# ADA Curb Ramp New Construction Inspection Form (Perpendicular)

Nw 292 st

23885.56

NW Keenon st

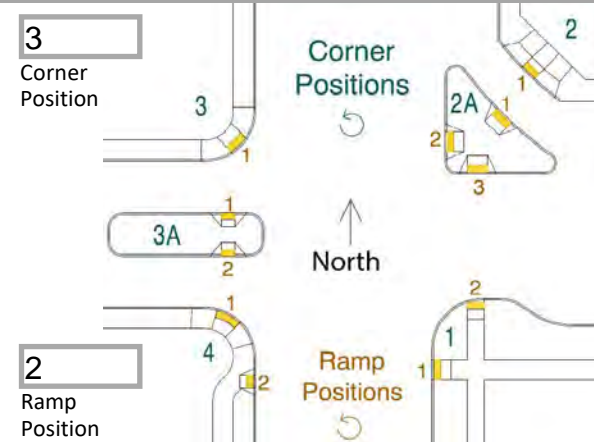
Detectable warning  
extends full width of  
ramp throat opening

☒

IITD- not full width
